III. Change in Fig. 3

In RE: Application of Joachim ZIMMER

Ser. No.: 09/787,572

MARKED-UP COPY OF ORIGINALLY FILED SPECIFICATION

FIG. IUS 5,920,948
= JP 10-278744

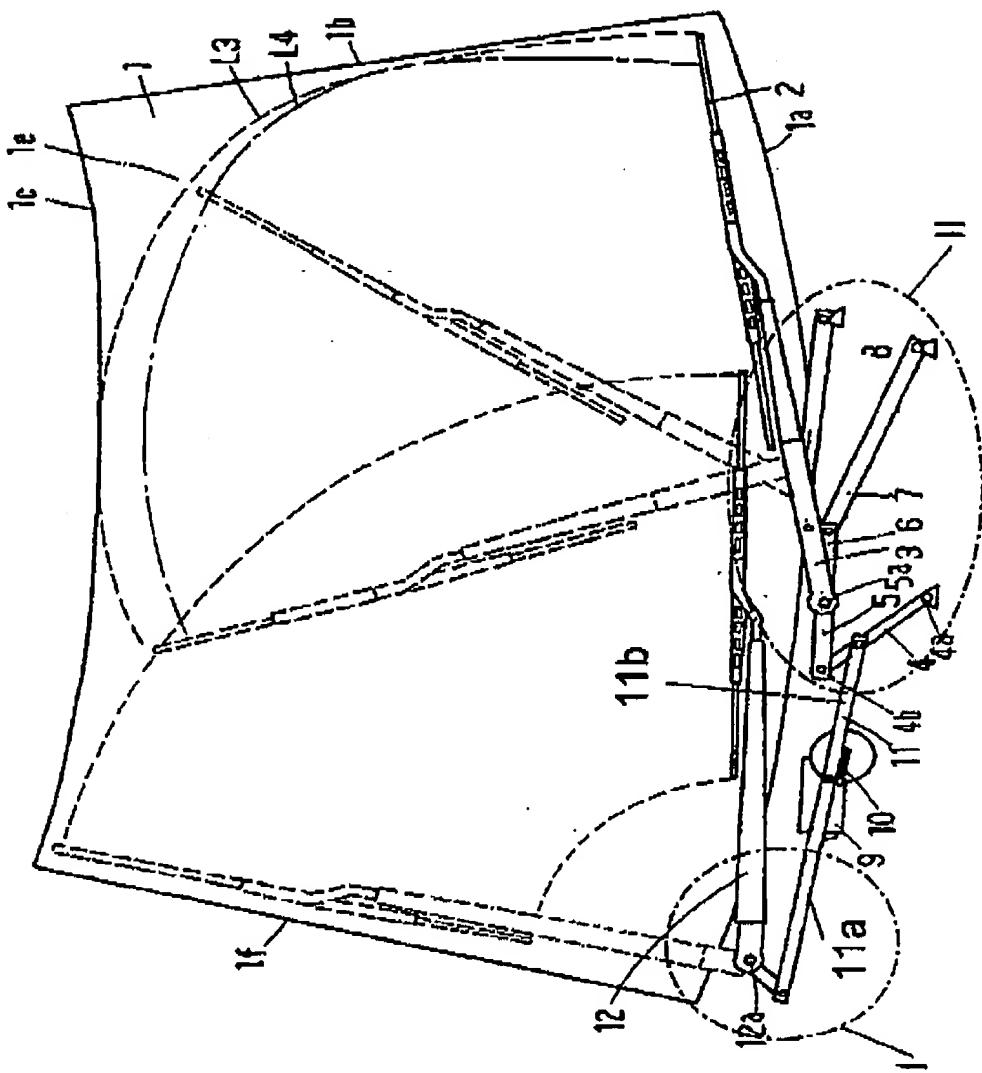
Amendment figure 1 is figure 1 of U.S. Patent 5,920,948, which is equivalent to Hayashi, et al, JP 10-278744. This amendment figure shows the prior art wiper drive apparatus of Hayashi, et al. Amendment figure 2 is figure 1 of the above-identified application, except that it is reflected about a central vertical axis, i.e. it is a mirror reflected figure 1 of the above application. This makes it easier to see the relationship of applicants' wiper drive apparatus and the wiper drive apparatus of the prior art.

Also dashed regions I and II are also shown in amendment figure 1, which shows the prior art wiper drive apparatus. These regions I and II of the wiper drive apparatus are the conventional lever drive mechanisms, which do not include the special distinguishing features of the present invention. Dashed

According to Hayashi, et al, the wiper 12 is driven by a wiper motor 9 by means of a link 10 and a link rod 11a by means of a wiper side crank in the conventional manner. For this purpose the link rod 11a is connected pivotally with the motor link 10 and the wiper side crank.

On the passenger side of this prior art wiper drive apparatus the wiper drive apparatus has a lever drive mechanism II for the wiper 3, which is formed as a multi-link drive mechanism, a four-link drive mechanism, as in the case of the present application. This sort of link drive mechanism superimposes a displacement motion on the pivotal motion of the wipers 3 and/or 12, so that the wiper blade 2 reaches further into the upper corner of the windshield and thus covers a greater area with the wiper, i.e. a larger wiper field. The multi-link drive mechanism, a four-bar link mechanism in the case of the present invention, has a drive link 4 and/or 36, which is driven by an additional coupling rod 11b and/or 28. The coupling rod 11b is pivotally mounted on the motor crank 10 of the wiper motor 9 on one end and on the other end on the drive link 4. In the common manner the coupling rods 11a and 11b are connected to the motor crank or link 10.

Amendment
Fig. 2

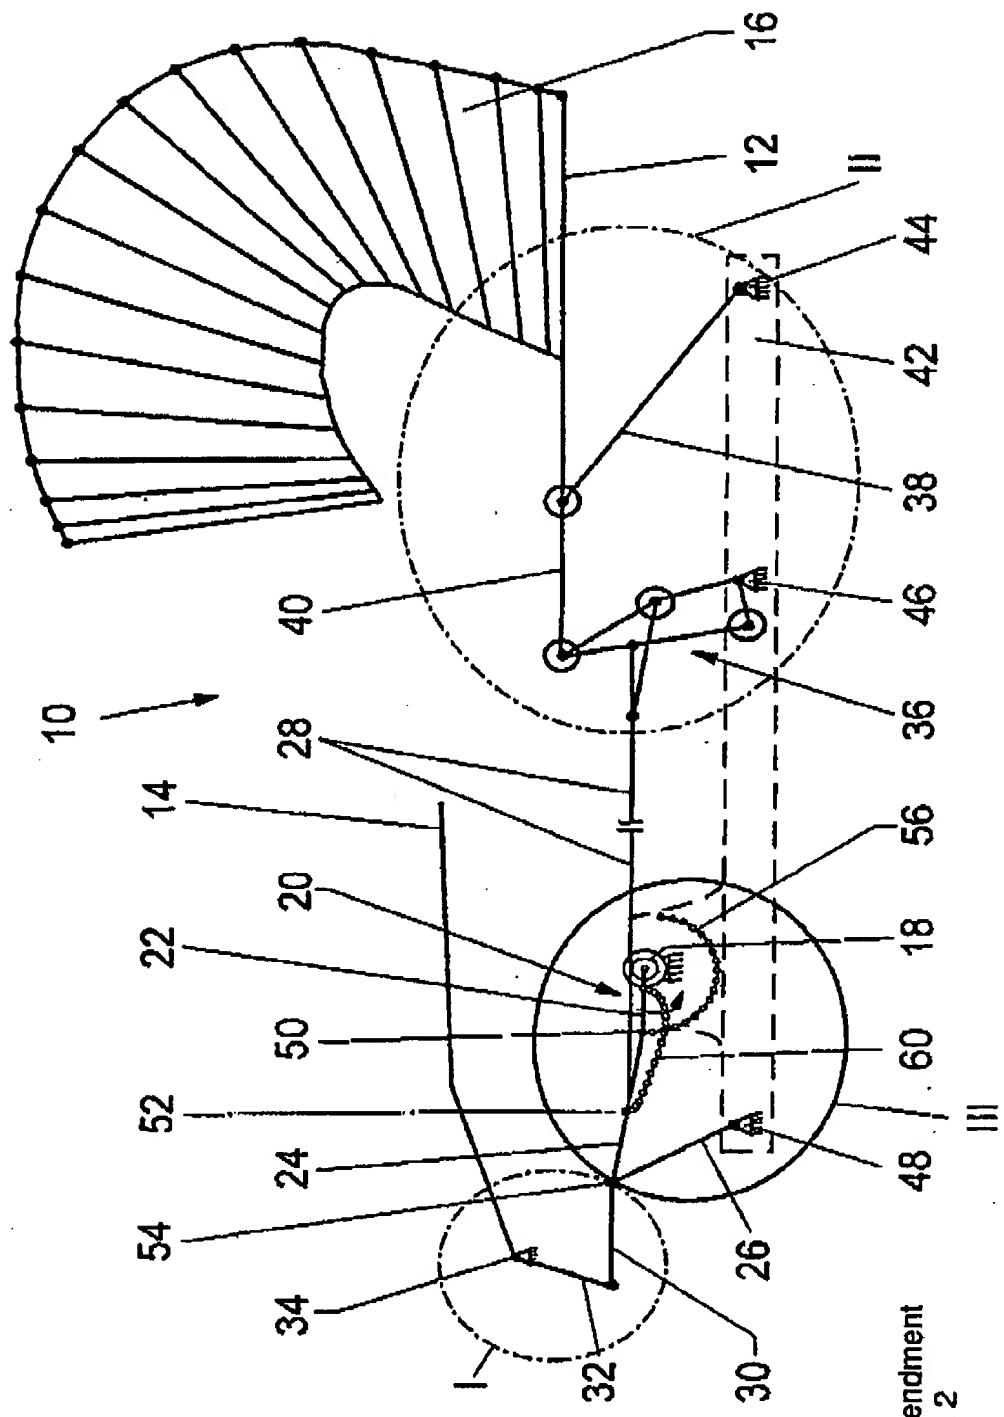
In addition amendment figure 2, which shows a preferred wiper drive apparatus of the applicants, includes three dashed circled regions or parts of the wiper drive apparatus. The dashed circle III shows the coupling mechanism 20, which the prior art wiper apparatus does not have. Dashed region II shows the first lever drive mechanism of claim 29 and 18. Dashed region I shows the second lever drive mechanism of claim 29.

In contrast the wiper drive according to the invention differs from the prior art on the side of the wiper motor indicated as region III, which includes the so-called coupling drive 20. The coupling drive 20 in region III, as claimed in claims

18 and 28, has a coupling rod 24, which is pivotally connected to the motor crank 22 on one end and pivotally connected with a link pivotally mounted on the chassis on its other end.

Because of the form of the coupling drive 20 according to the invention in region III surface motion curves of the coupling rod are achieved, which can be adjusted to the structural conditions in the vehicle and the position of the wiper motor 18 relative to the windshield wiper. Thus harmonized motion paths result on the windshield. The prior art wiper drive apparatus according to Hayashi, et al, cannot achieve the desirable kinematics achieved by the structure according to the invention. In contrast, the added coupling mechanism 20 provides greater flexibility in locating the drive motor in order to provide the better kinematics, but is nevertheless comparatively compact and simple.

Fig. 3

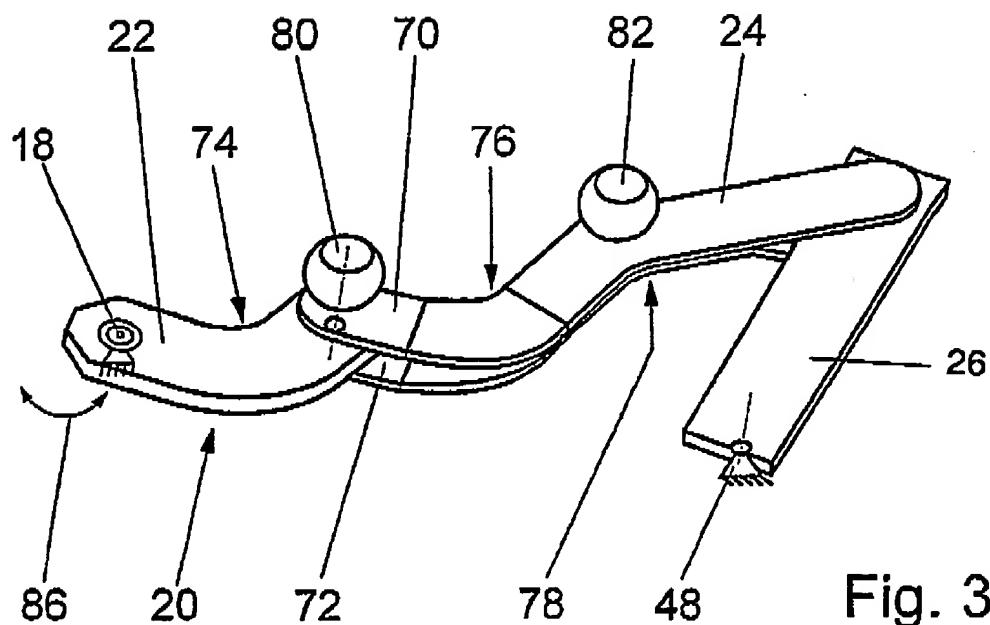
The original figure 3 incorrectly assigned "guide rod 26", as described in the detailed description, the drawing reference number 38.

A copy of drawing sheet 3/5 including figure 3 with the appropriate change of reference number 38 to 26 accompanies this amendment. Approval and entry of the change in figure 3 is respectfully requested.
